Appendix C

FACILITY: Roripaugh Residential Ranch WDID: 9 00001C091 INSPECTION DATE: August 29, 2006
9 0000512S1
9 33C320657

Introduction

Photo 04: Sediment traps were immediately installed along Murrieta Hot Spring Road to contain and capture the sediment-laden water.

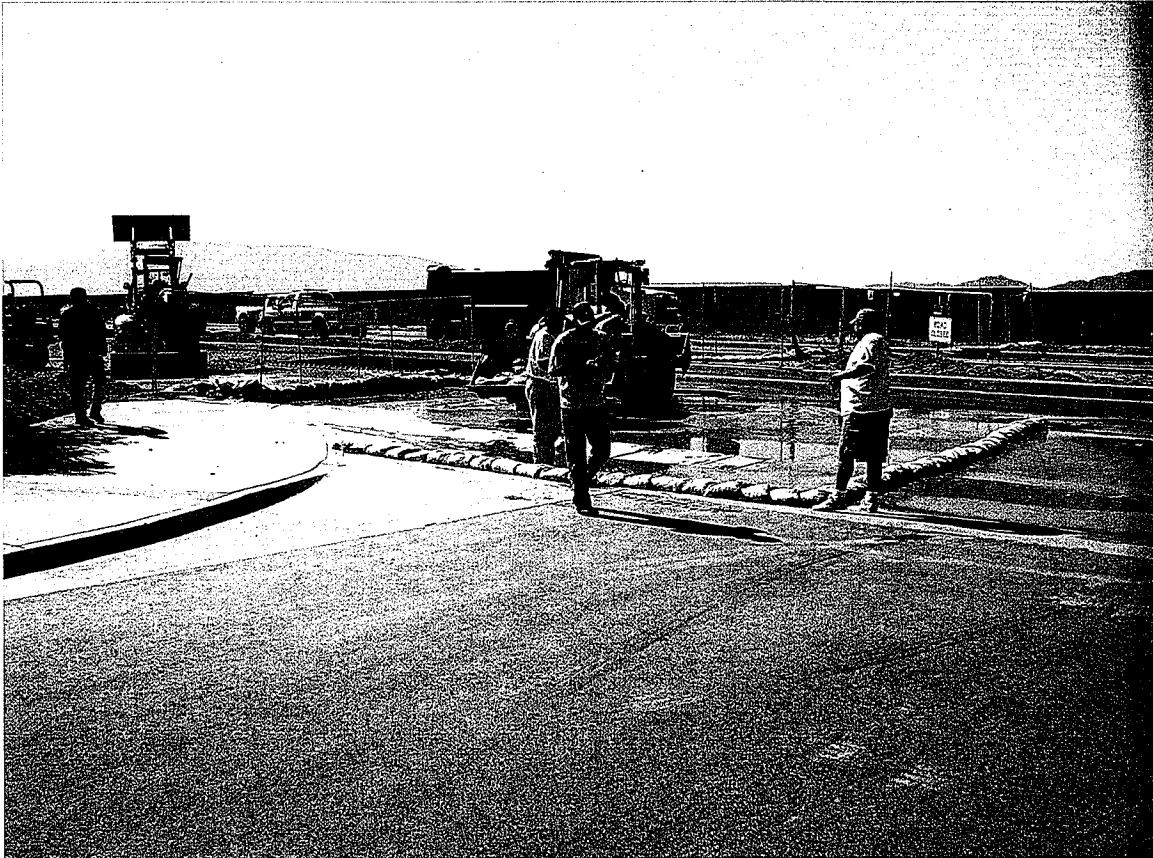
Photo 01: Ashby, USA workers attending to water line break. Initially, the workers were observed erroneously removing the gravel bags releasing the sediment-laden water along Murrieta Hot Springs Road.

Photo 02: Our presence quickly alerted the Ashby works to maintain the BMPs, as sediment-laden water entered the storm drain along Murrieta Hot Springs Road.

Photo 03: Workers attempting to shut off the water main. The SWPPP person, Mr. Henry Martinez, and his supervisor were present at the time of the incident.

Photo 06: Site entrance at Pourroy Road off Murrieta Hot Springs Road in Temecula, CA.

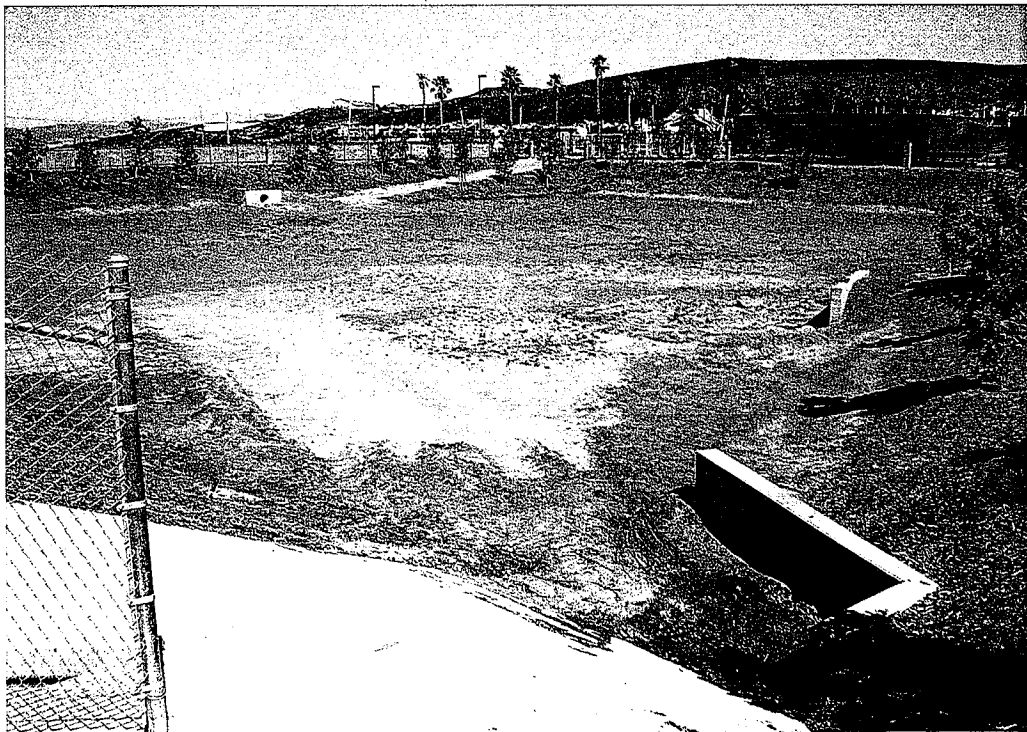
Photo 05: We notified Mr. Aldo Licitra of the City of Temecula of the incident. He proposed to conduct a follow up inspection of the incident to ensure proper clean up of the sediment that was deposited along Murrieta Hot Springs Road. The incident occurred the moment we approach the site entrance on Pourroy Road.

About an hour later, the Ashby workers had laid out a series of sediment traps along Murrieta Hot Springs Road to contain the sediment discharge. The closest storm drain, located at the intersection on Red Bridge Road, was protected with gravel bags to contain the runoff.

There was discharge into the City's storm drain located at the intersection of Murrieta Hot Springs Road and Red Bridge Road, which is in violation of the City of Temecula's Municipal Separate Storm Sewer Systems (MS₄) permit.

Photo 08: Placement of the basin outflow indicates the design is a flow-through system, eliminating settling time.

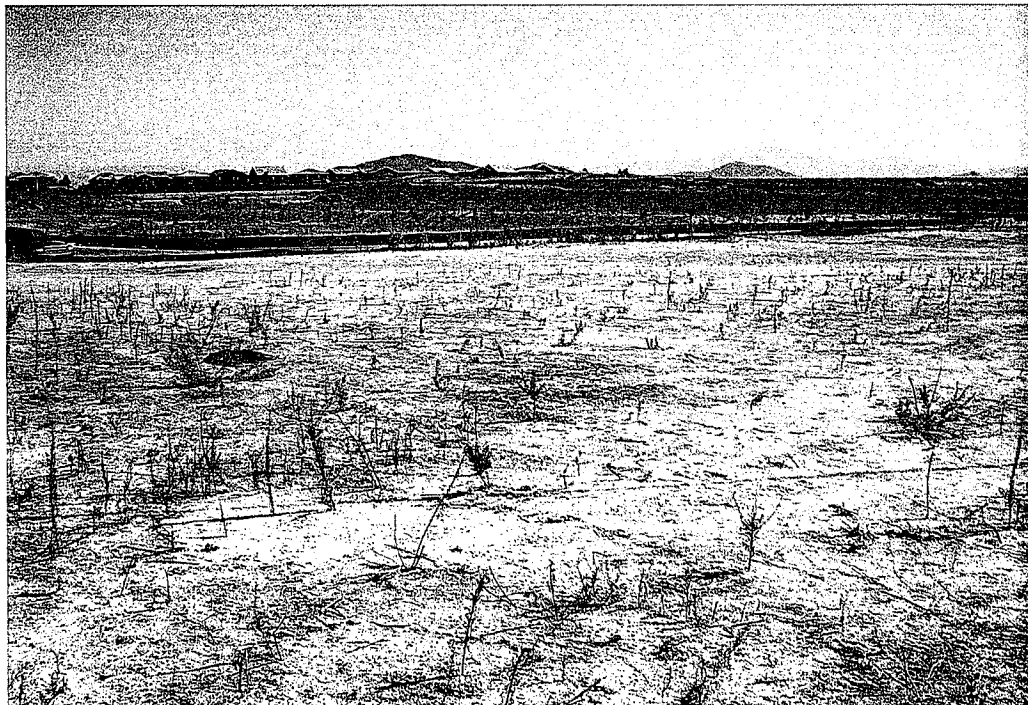
Photo 07: The sediment basin is expected to contain storm water runoff from adjoining east and west graded lots (referred to as the Plateau).

Photo 12: Culvert pipe-shows buildup of sediment deposit from discharges from sediment basin.

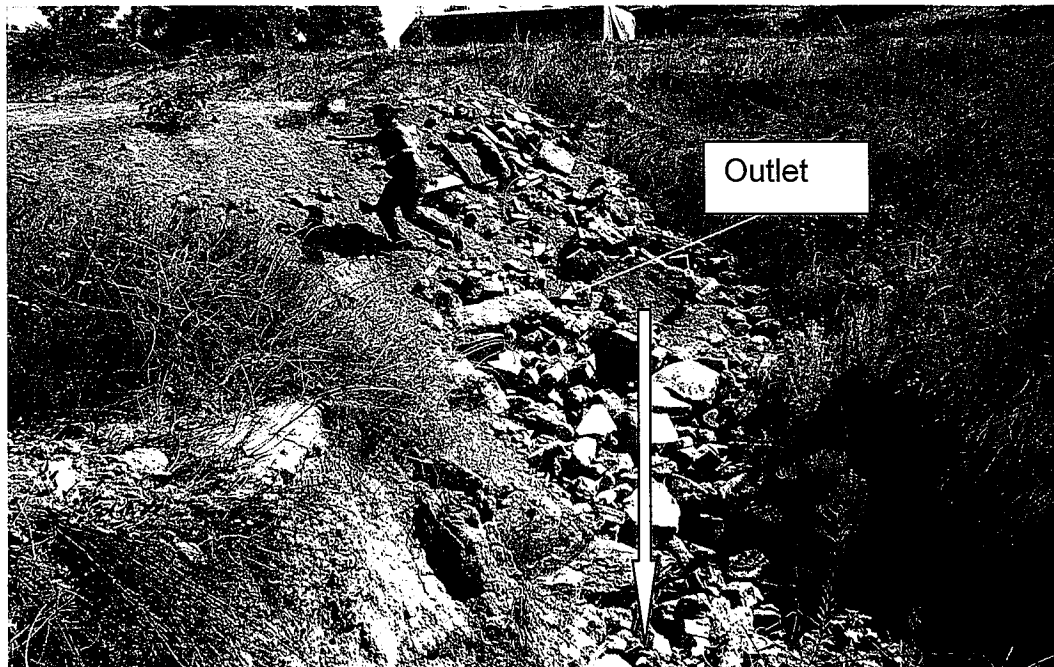
Photo 09: Most of the storm water runoff to the sediment basin comes from the 'plateau' portion of the site and the adjoining graded parcel (west).

Photo 10: Insert shows outlet of sediment basin with velocity diffuser (barely visible because it is covered with sediment). Subsequent photos will trace the path of discharge from the sediment basin to the complainant's property.

Photo 11: Runoff from the sediment basin continues through this grassy swale exiting through the culvert pipe (seen in background).
